SUBJECT: RIVER BEND STATION, UNIT 1 - ISSUANCE OF AMENDMENT RE: INCREASE  
IN MAXIMUM ALLOWABLE THERMAL POWER TO 3039 MEGAWATTS  
THERMAL (TAC NO. MA6185)

The amendment changes the FOL and the TSs to allow an increase in the maximum, allowable thermal power from 2894 megawatts thermal (MWt) to 3039 MWt.

- Enclosures: 1. Amendment No. 114 to NPF-47
- 2. Safety Evaluation
- 3. Notice of Issuance

Figure 3.4.11-1 (page 1 of 1)  
Minimum Temperature Required vs. RCS Pressure

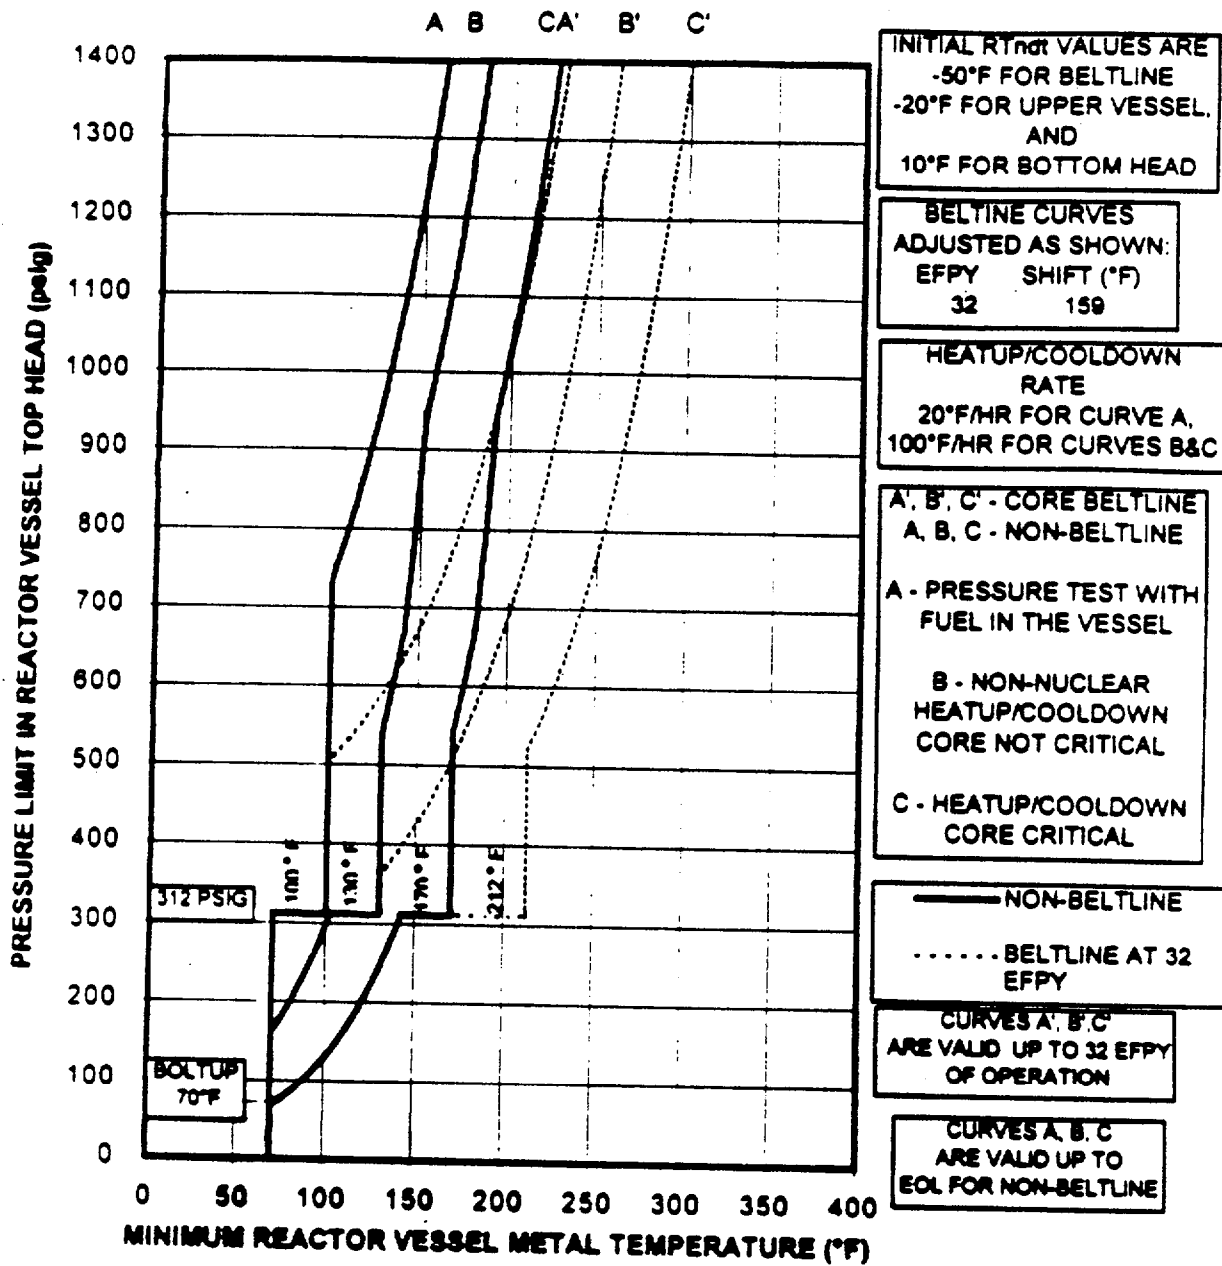
14. RCS P/T Limits, TS Figure 3.4.11-1 and SR 3.4.11-1

As noted in Section 3.2.3 herein, the licensee has proposed the adoption of 32 EFPY P/T limits. This proposal involves the replacement of TS Figure 3.4.11-1 and associated changes to SR 3.4.11.1 and SR 3.4.11.2, "RCS Pressure and Temperature (P/T) Limits." As noted in Section 3.2.3 herein, adoption of the 32 EFPY P/T limits is acceptable; accordingly, these proposed TS changes are acceptable.

The NRC staff approves the use of the P-T limit curves (designated as "32 EFPY" curves) through 16 EFPY of operation. For continued operation beyond 16 EFPY, additional information to address staff concerns regarding the RBS fluence calculations must be provided or an amendment to the P-T limit curves submitted. By letter dated May 8, 2000, EOI committed to use the "32 EFPY" curves in the power uprate request until the test results from the first RBS surveillance capsule were acquired and EOI received NRC approval to implement revised P-T limit curves based on this information. In accordance with the current RBS RPV surveillance capsule program, this information will be submitted to the NRC staff, as required by the reporting requirements of 10 CFR Part 50, Appendix H, with sufficient time for NRC staff review and action before the RBS RPV exceeds 16 EFPY of operation. Should EOI request NRC staff approval to modify the RBS RPV surveillance program, EOI should address how these modifications will affect their ability to meet the commitment in their May 8, 2000, letter and address how continued operation of the RBS RPV will be demonstrated in light of the surveillance program modifications.
